F / 001 / Client / 211221 903

Architectural Design Statement

This architectural design statement sets out the response by Team 2 Architects in relation to the Stage 2 expansion of the Northside West Mental Health facility located in Wentworthville, NSW.

12.0 State Design Review Panel.

Diagram indicating the effect of installing a ramp to accommodate a 1m level change between Stages 1 and 2 developments.

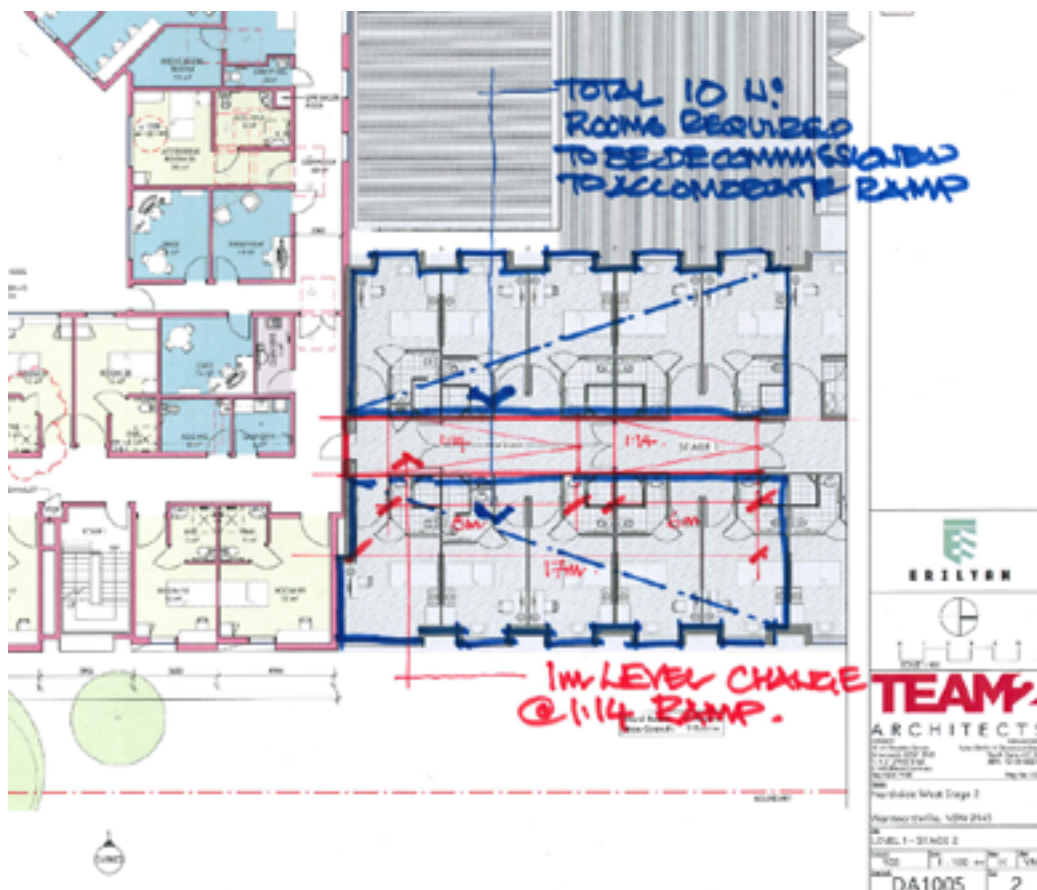
As has been discussed in detail in this document, the operational and patient safety aspects of this type of facility take top priority. Comment has been received concerning the possibility to reduce the height of the Stage 2 development by reducing the Level RL, thus misaligning the critical connection between Stages 1 and 2.

The Australasian Health Facility Guidelines (AHFG's) make a statement to the effect that changes of level within a clinical facility of less than a storey is considered poor practice and should be avoided wherever possible – the reasons behind this are numerous, but mainly focus around patient movements, safe staffing standards, movement of beds and trolleys etc. It therefore not advisable to incorporate level changes within a floor plate.

In addition, to achieve this between stages 1 and 2 would result in a large number of rooms being decommissioned due to the need for a ramp within the corridor of one or other of the stages.

Having regard for the above, we therefore do not this is a practical or reasonable suggestion.
